PLAN REVIEW SHEET

2015-034

Synco Properties

Waiting Pad Detail

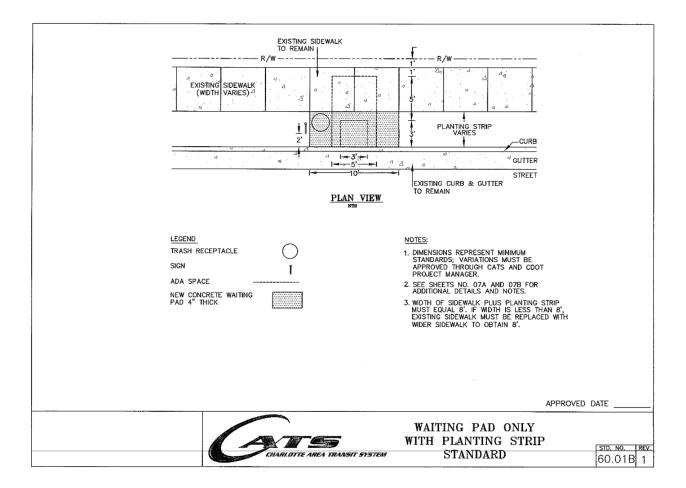
The Petitioner is requested to provide and construct a concrete pad for the existing bus stop on Sharon Road. Below is an image of the standard detail (60.01B) for the requested concrete pad. The site plan may either show the conceptual location of the improved bus stop on Sharon Road, or alternatively, include a development note to locate the bus stop pad during the urban review process.
